03-55078 ✓  
**PERMIT**

**SEWAGE DISPOSAL SYSTEM**  
HOWARD COUNTY HEALTH DEPARTMENT  
BUREAU OF ENVIRONMENTAL HEALTH  
410-313-2640

SUBDIVISION Brantwood 2/1 LOT NUMBER 30 ADDRESS 3000 Seneca Chief Trail

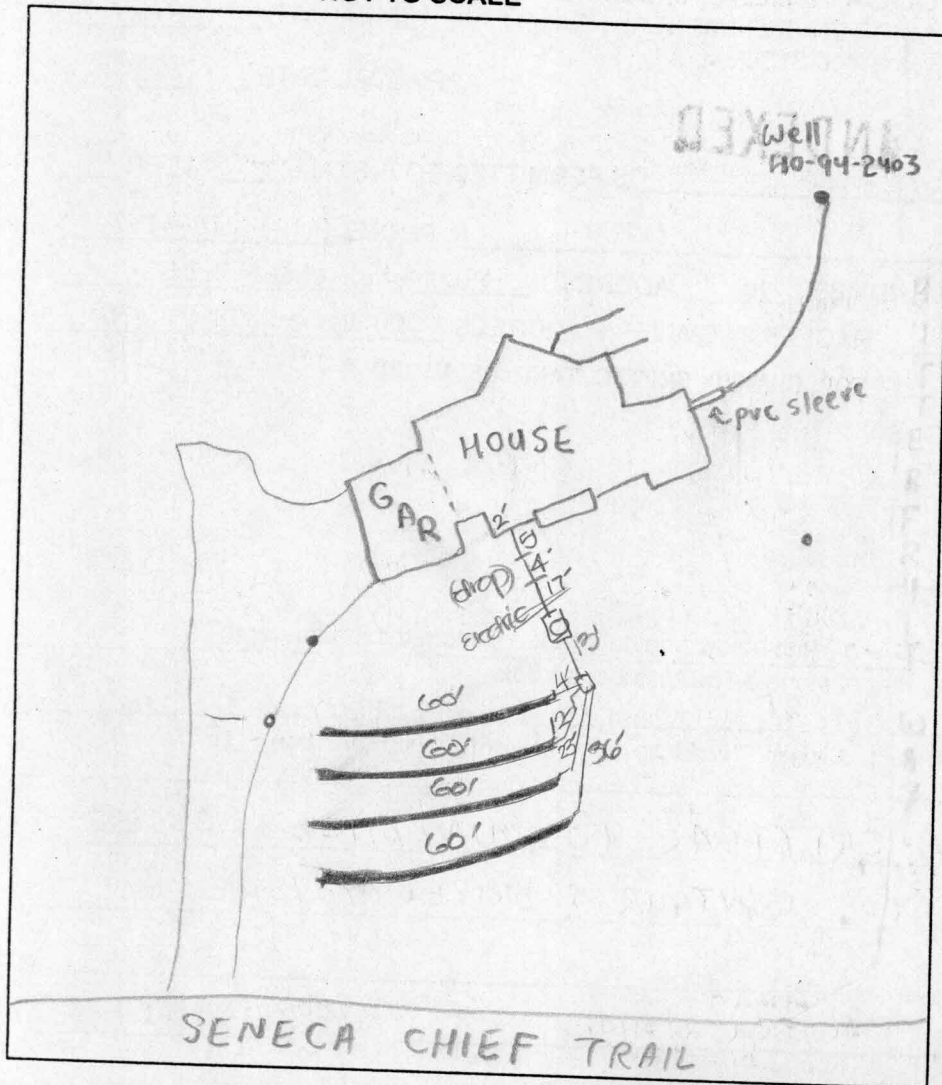
LAYOUT INSPECTION CRITICAL TO MINIMIZE LOSSES  
OF SEPTIC AREA DUE TO CONTOUR & DRIVEWAY ISSUES

PRE-CONSTRUCTION INSPECTION: 6/19/01 - EASEMENT STAKED, SET D. BOX PER PLAN BUT RUN

4- 60' TRENCHES TOWARDS 205.00' LOT LINE IN THE EVENT DRIVEWAY IS PAVED WIDER

THAN PROPOSED (SRW)

7/3/01 FINAL INSP - OK to cover all septic work. DKC
